Re: 102 Broomfield Street Cabramatta (Traffic)– Request for Information (RFI)

This letter contains information regarding the vehicle swept paths, traffic signal operations and vehicle manoeuvrability for the site at 102 Broomfield Street Cabramatta.

Swept Path Assessment - Basement Level 2
B99 Entry/Exit movements

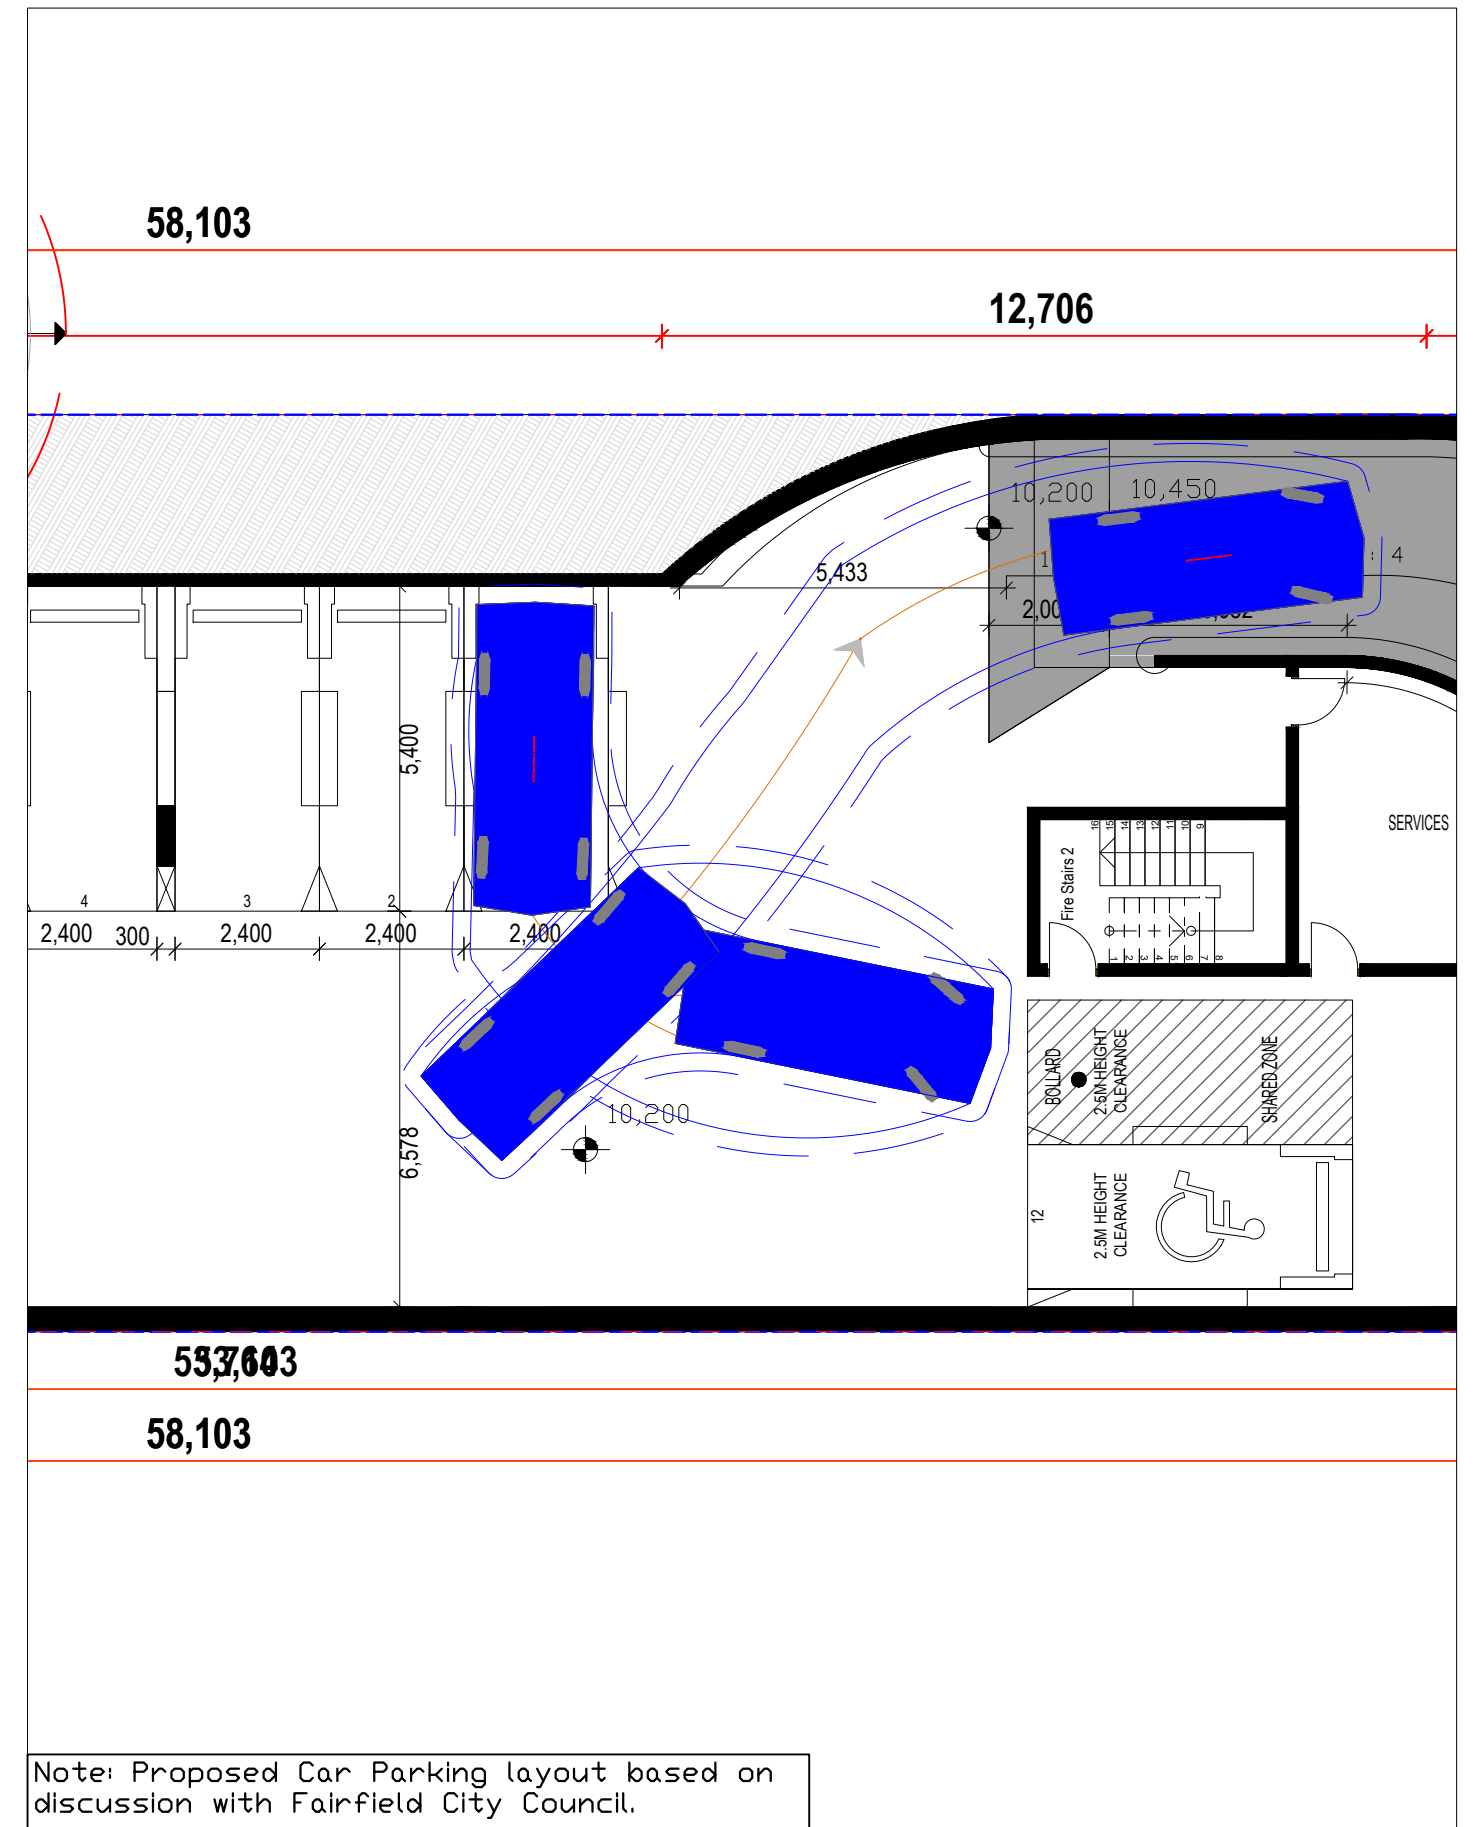
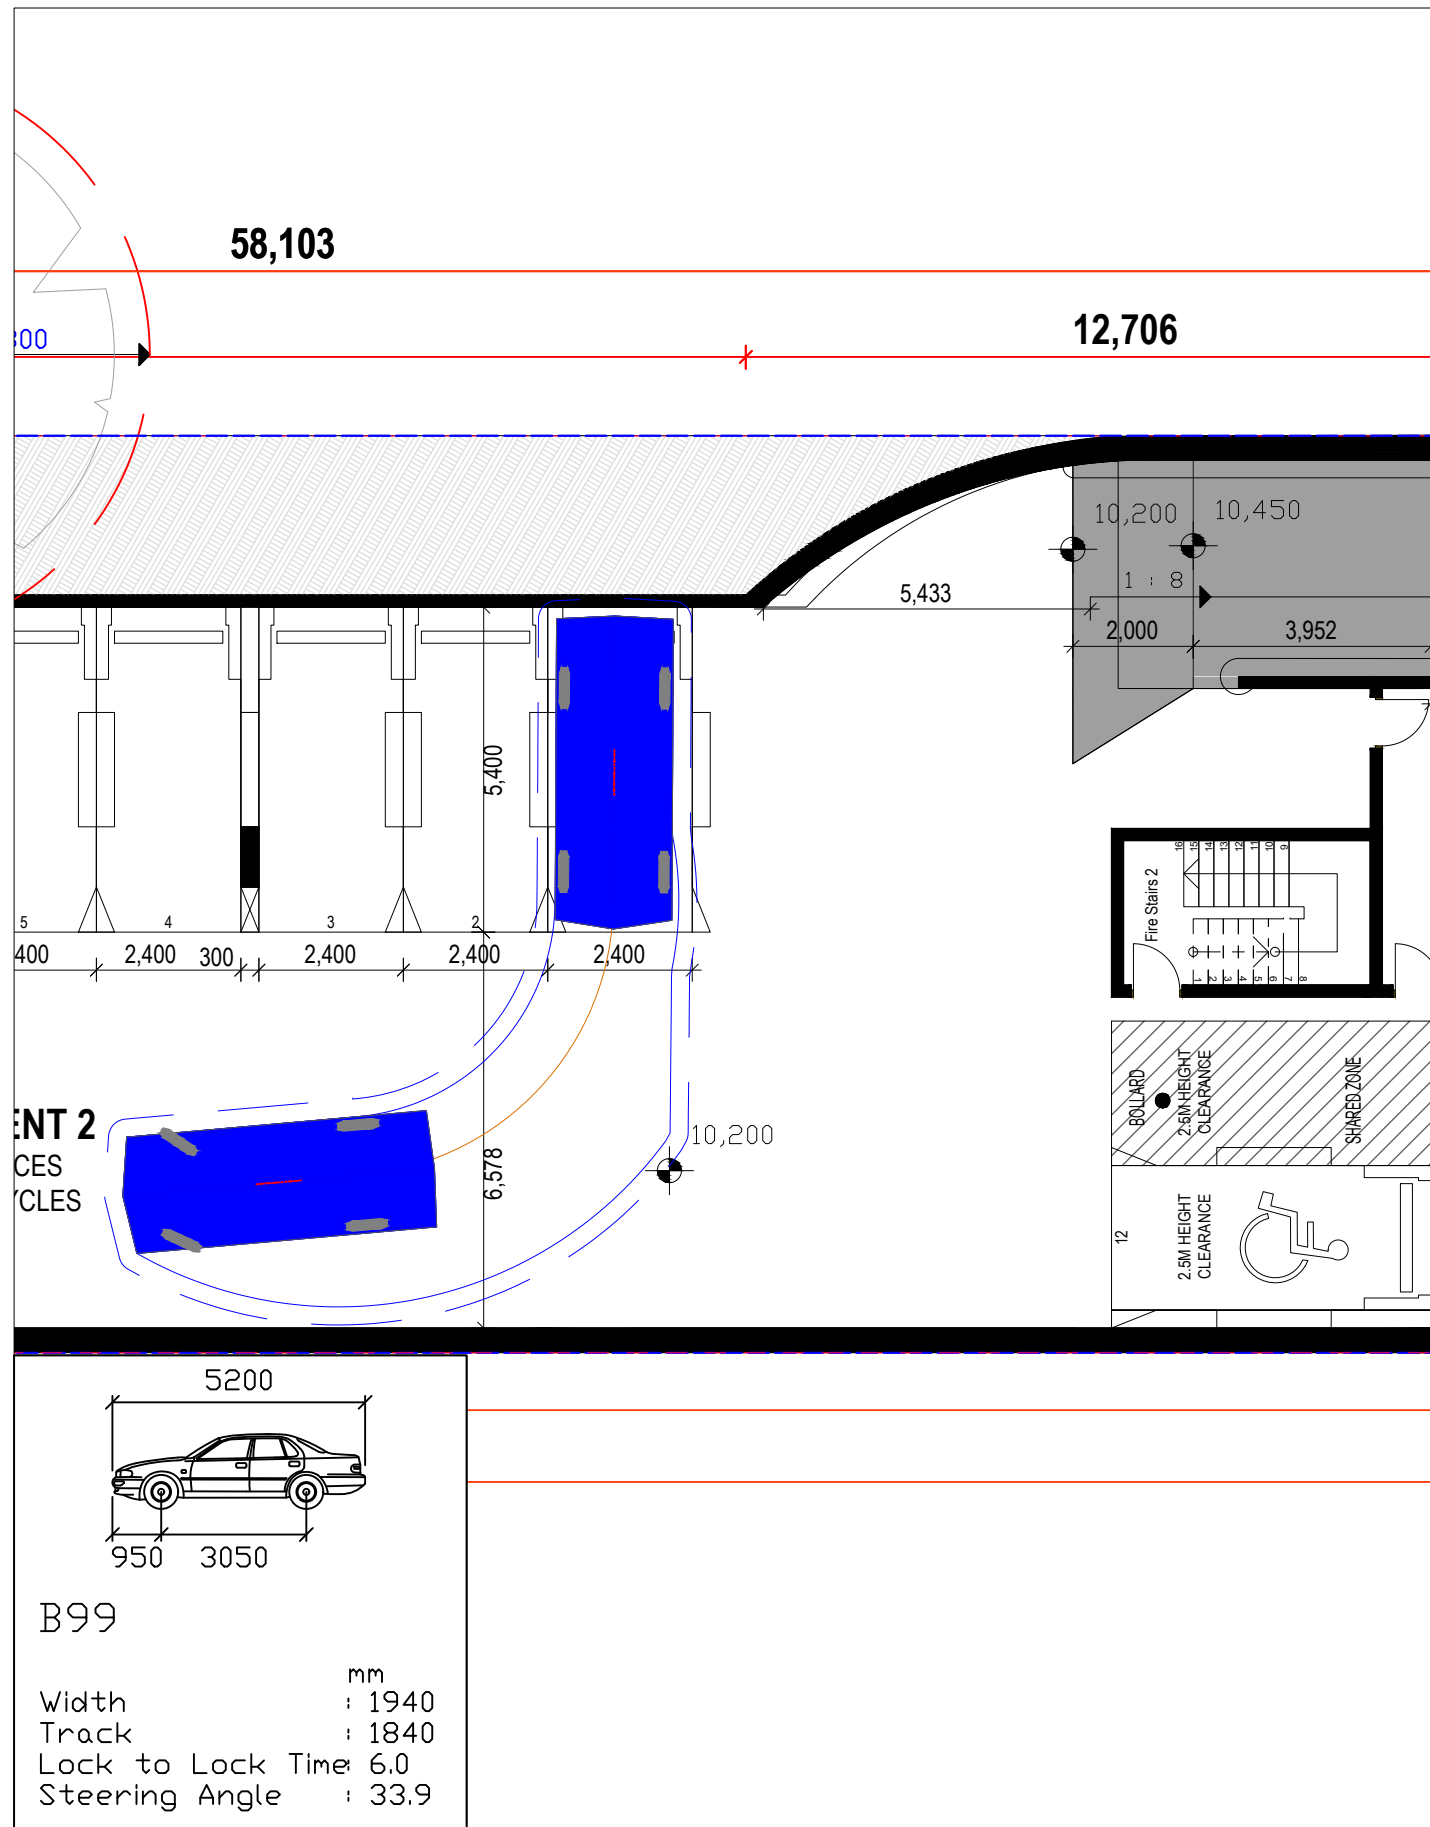
The proposed access is a 6.0 metres wide ramp allowing for two vehicles to pass between ground level and basement 1. However, due to the constraints of the site, inbound vehicles wanting to access basement 2 will have to enter the opposing lane to make the turn (refer to vehicle swept paths in Appendix B).

1. Inbound vehicles will enter the site via Broomfield Street
2. In order to access the ramp to basement 2, the inbound vehicle will need to intrude into the opposing lane
3. The inbound vehicle will have 'priority entry'. This entails a continuous green signal on basement 1, and basement 2 will have the 'red' light
4. For an outbound vehicle on basement 2. The driver would activate the traffic lights via a sensor or push button remote. The traffic signals would then be activated 'red' on basement 1 to aware drivers that a vehicle is exiting from basement 2. If there is an inbound vehicle wanting to go to basement 2. The inbound vehicle will have to wait in the waiting area (in Basement 1) to allow the outbound vehicle to pass.
